Proposal #08: Project ID 1130-66-82, WISC 2026008
Appleton – De Pere
Buchanan St Overpass
IH 41
Outagamie County

Letting of October 14, 2025

This is Addendum No. 01, which provides for the following:

ADDENDUM NO. 01

SHEET 15A

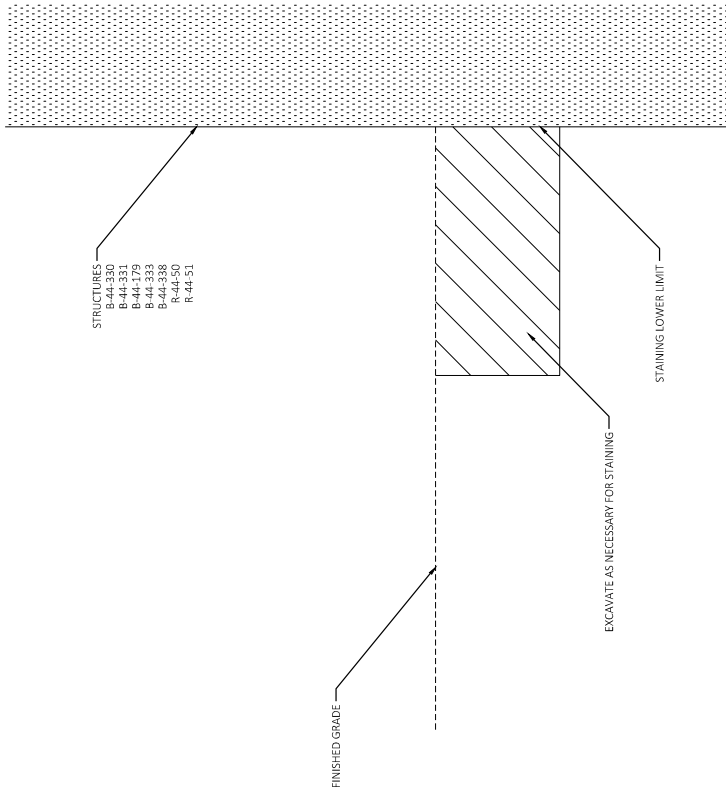
Added Plan Sheets	
Plan Sheet	Plan Sheet Title (brief description of why sheet was added)
15A	Construction detail for added bid items included.

- EXCAVATION AS REQUIRED
- RESTORATION FOR DISTURBED AREA IS PAID FOR AS CONCRETE STAINING - EXCAVATION, GRADING, SHAPING, AND FINISHING STRUCTURE
